802.3 Clause 104 (802.3cg and 802.3- 2018) Maintenance Requests

G. Zimmerman (CME Consulting), Heath Stewart, and
Karl Peterson (ADI)

Technical, 802.3bu, Page 53, Figure 104-8

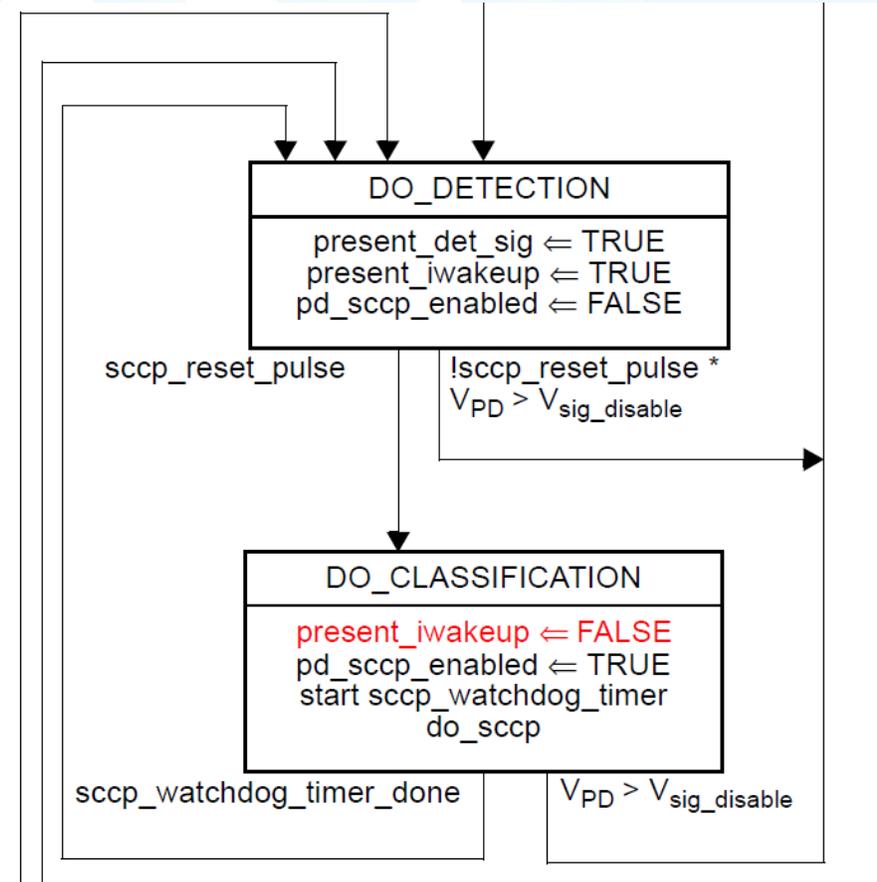
The PD state machine, as written, requires present_iwakeup to be TRUE in DO_CLASSIFICATION based on an assignment derived from DO_DETECTION. During classification the PD is engaged in SCCP signaling and cannot simultaneously present the iwakeup signature.

Modify Figure 104-8 as follows, specifically setting present_iwakeup to FALSE in DO_CLASSIFICATION.

Technical, 802.3bu, Page 53, Figure 104-8

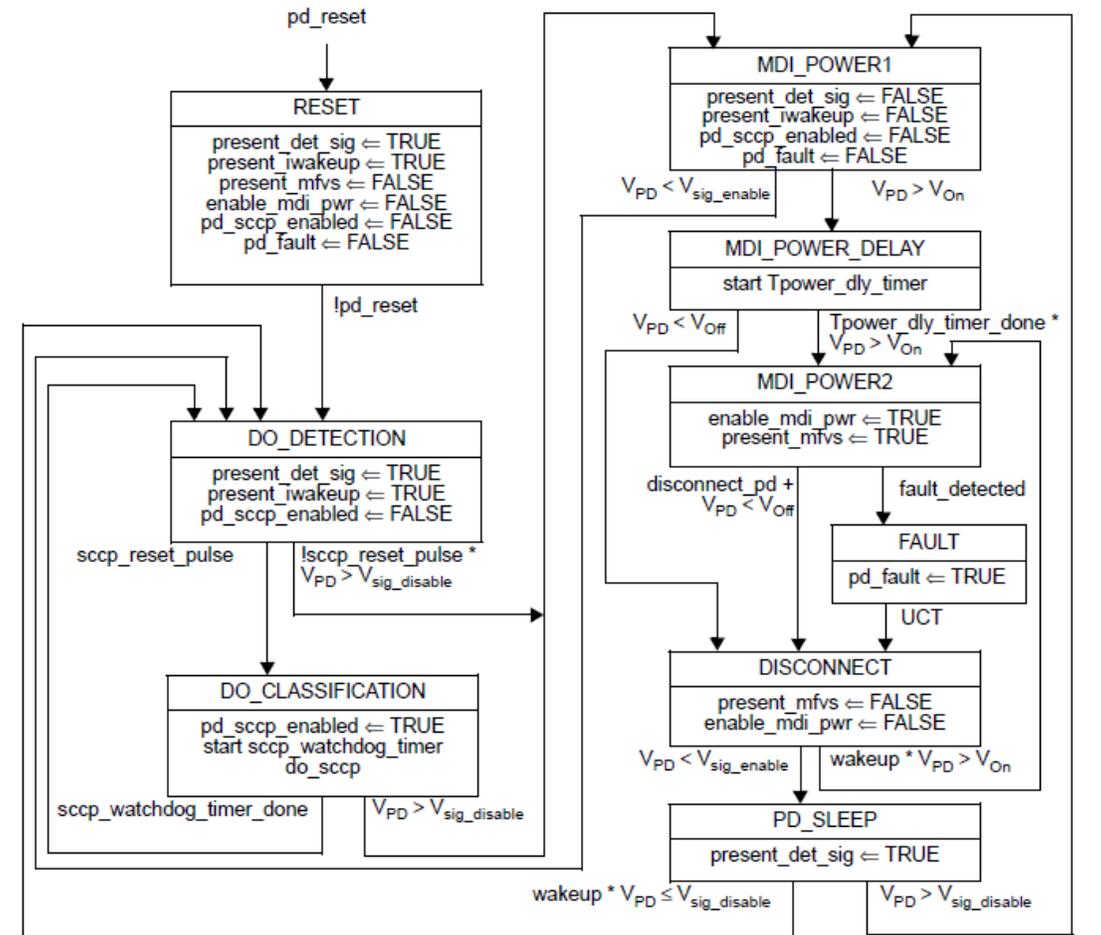
The PD state machine, as written, does not allow a PD to respond to SCCP classification on PD_SLEEP exit.
